STAFF RECOMMENDATION 3701 Richland Avenue Lot 14, Richland Hall Development August 16, 2017

Application: New construction—infill and outbuilding
District: Richland-West End Neighborhood Conservation Zoning Overlay
Council District: 24
Map and Parcel Number: 10409012100
Applicant: Chad Gore, Mike Ford Builders
Project Lead: Melissa Baldock, melissa.baldock@nashville.gov

Description of Project: Application is to construct a new single family infill and an outbuilding. Both the infill and the outbuilding require a side setback determination.

Figure 2. Overall site plan for the 22 infill houses planned for the Richland-West End Neighborhood Conservation Zoning Overlay. The red box indicates the site currently under consideration.

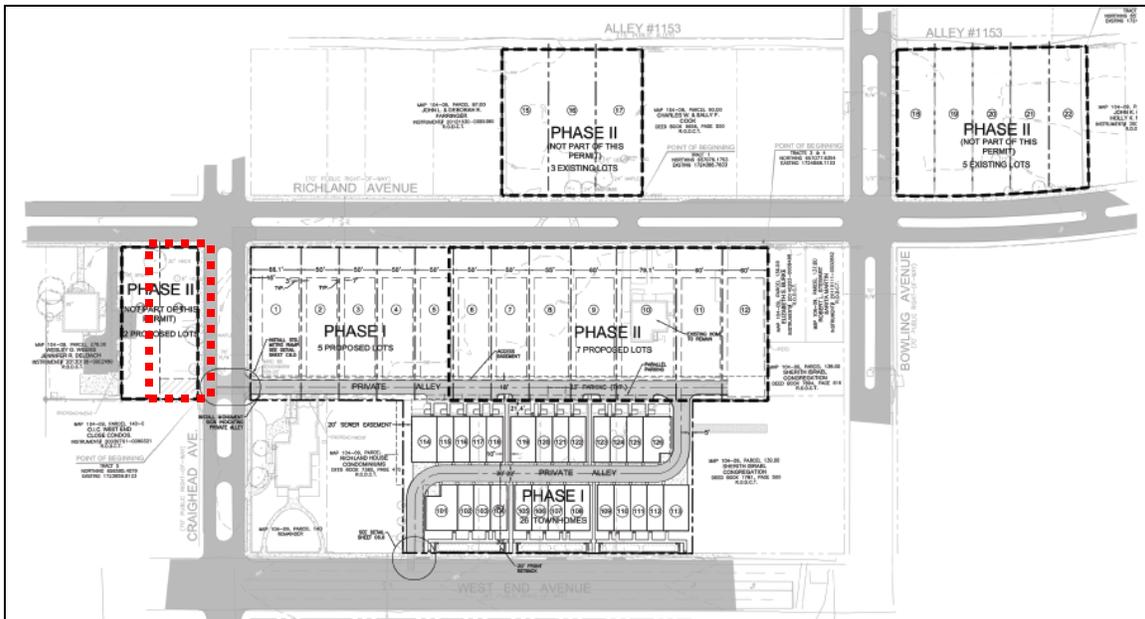
Setback & Rhythm of Spacing: The front setback is proposed to be approximately forty-eight feet (48’) to the front wall of the house, or forty feet (40’) to the front porch. This is identical to what the Commission approved for the other lots in the Richland Hall

The closest historic house on this side of Richland Avenue is 3705 Richland Avenue, and that house has a front setback of sixty feet (60') to the front wall, or forty-nine feet (49') to the front porch. Across Richland Avenue, the historic houses sit approximately forty-six to forty-seven feet (46'-47') from the front property line (Figure 3). Staff finds that the proposed front setback, which has a front wall twelve feet (12') forward of the front wall at 3705 Richland Avenue, is not appropriate. Staff recommends that the infill be pushed back by two feet (2') so that its front wall is ten feet (10') forward of the house at 3705 Richland Avenue. Staff will further recommend that the new infill proposed for the lot next door at 3703 Richland Avenue be set back an additional five feet (5') so that there is a transition from the front setback at 3701 Richland Avenue to the front setback of the historic house at 3705 Richland Avenue.

The infill will be five feet (5') from the left side property line and will be over sixty-five feet (65') from the rear property line. With the condition that the front wall of the house be pushed by two feet (2'), staff finds that the proposed setbacks to be similar to the immediate historic context and to meet Section II.B.1.c. of the design guidelines.

FRONT ELEVATION (RICHLAND AVE.)

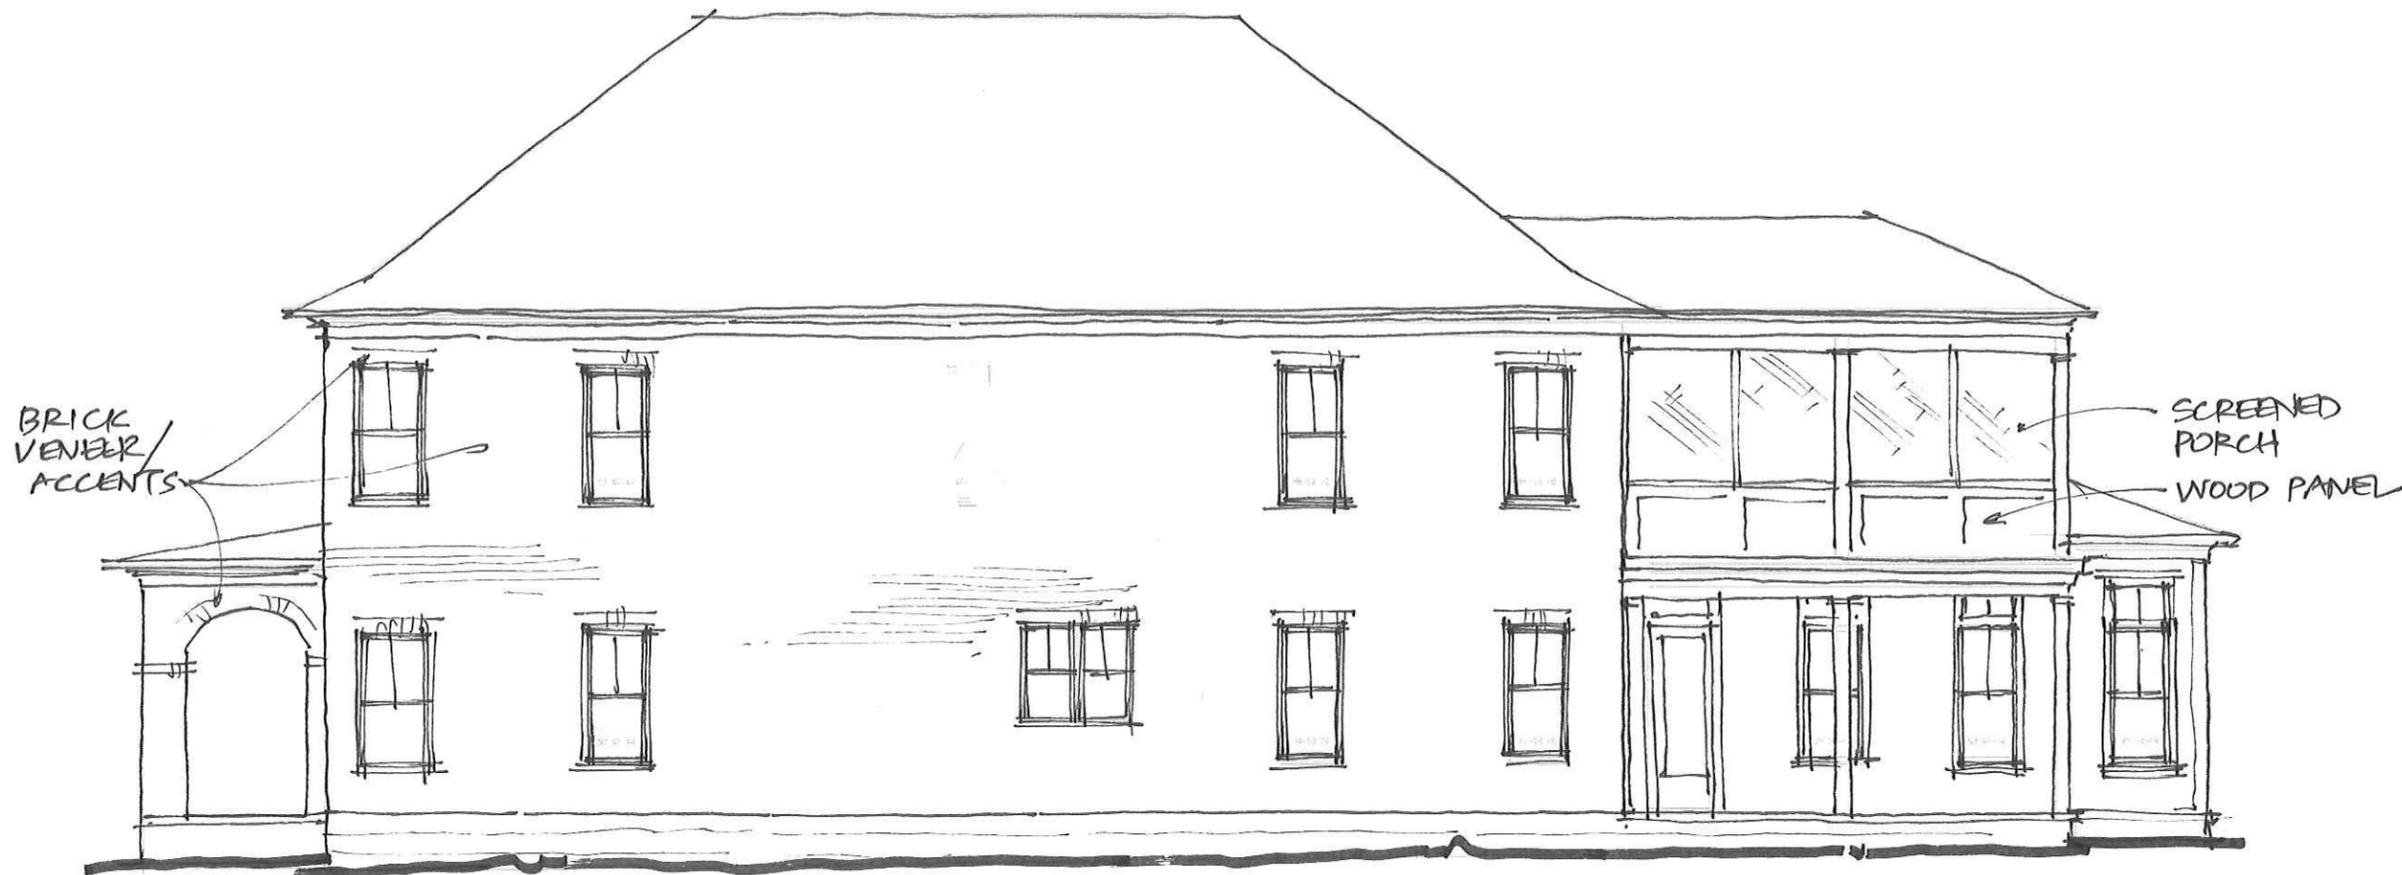
Height & Scale: The proposed infill will be two stories, with a maximum height of thirty-four feet, six inches (34’6”) above the foundation at the front, and approximately thirty-seven feet, nine inches (37’9”) above grade. The infill will have an eave height of approximately twenty-four feet (24’) above the grade at the front. The foundation height will vary due to grade, but will be about two feet (2’) tall at the front. Staff finds that the proposed height is similar to the heights of historic houses in the immediate vicinity, which range from thirty to forty-four feet (30’ – 44’). It is also in keeping with what has been approved in the past for the infill houses in this development.

Roof form: The infill's primary roof form is a hipped roof with an 8/12 pitch at the front. The front porch roof will have a 2/12 hipped roof. Other secondary roofs, like the second story bays and rear porches will be hipped with slopes of 4/12. Staff finds that the proposed roof forms are appropriate for a two-story infill house in the overlay, and finds that the roof forms meet Section II.B.1.e. of the design guidelines.

Proportion and Rhythm of Openings: The proposed windows on the infill are generally twice as tall as they are wide, thereby meeting the historic proportion of window openings. There are no large expanses of wall space without a window or door opening. All double and triple window openings have a four to six inch (4"-6") mullion in between

Staff recommends verification of the construction height of the foundation and floor systems in the field to ensure that the finished floor line of the new construction is compatible with the historic context. With this condition, staff finds that the height and scale meet Sections II.B.1.a. and II.B.1.b. of the design guidelines.

GARAGE ELEVATIONS

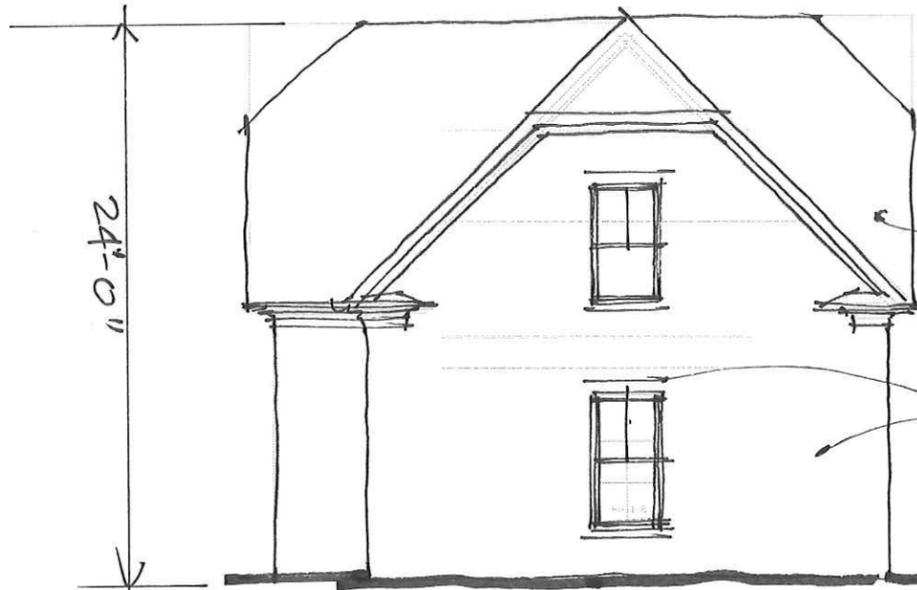
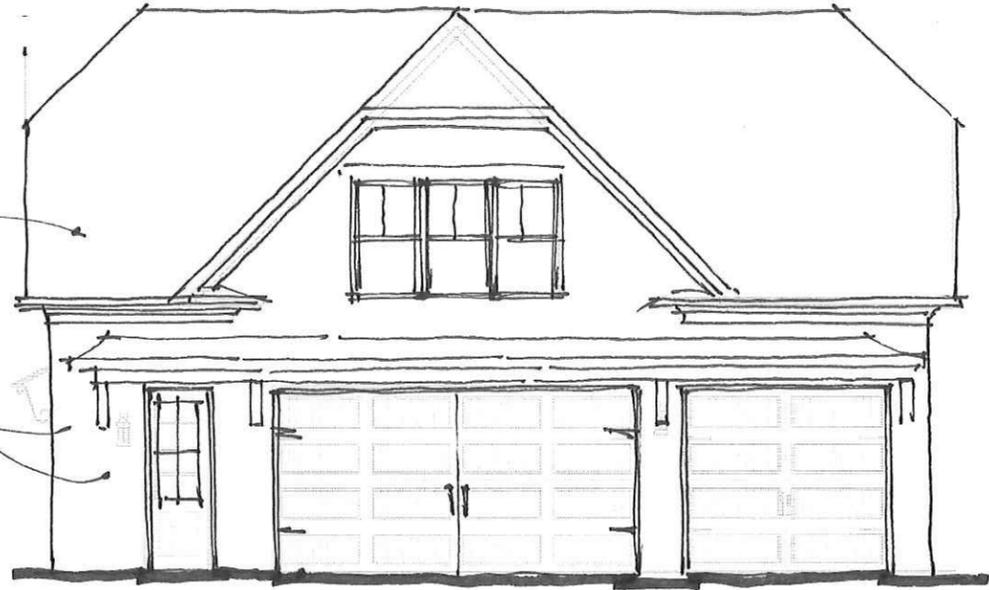
*The Commission typically requests to see at least twenty feet (20’) between the primary structure and the outbuilding. The applicant is proposing just twelve feet (12’) in between the structures. The Commission has approved a distance of as little as ten feet (10’) in between the primary structures and the outbuildings for Lots 1, 2, 3, 4, 5, 6 and 11 of this development. Staff recommends approval of the distance between the infill and the outbuilding for Lot 14. The overall development is creating a new alley at the rear of the lots, which will make the back portion of the lot unavailable for building. Approximately the back twenty feet (20’) of the lot is used for the alley. Therefore, staff finds that the distance in between the primary house and the outbuilding to be sufficient.

**The outbuilding a requires a side setback determination on the left/Craighead Avenue side. When an outbuilding is on a corner lot, the base zoning setback is typically ten feet (10’). The applicant is proposing a Craighead Avenue side setback of just six feet (6’). Staff finds that the proposed six foot (6’) side setback is appropriate for several reasons. It will match the side setback of the new infill on the lot, and it will be similar to the Craighead Avenue side setbacks for the outbuildings located on the other corners of Richland Avenue and Craighead Avenue.

With the final approval of all materials, staff finds that the proposed outbuilding meets Section II.B.1.h of the design guidelines.
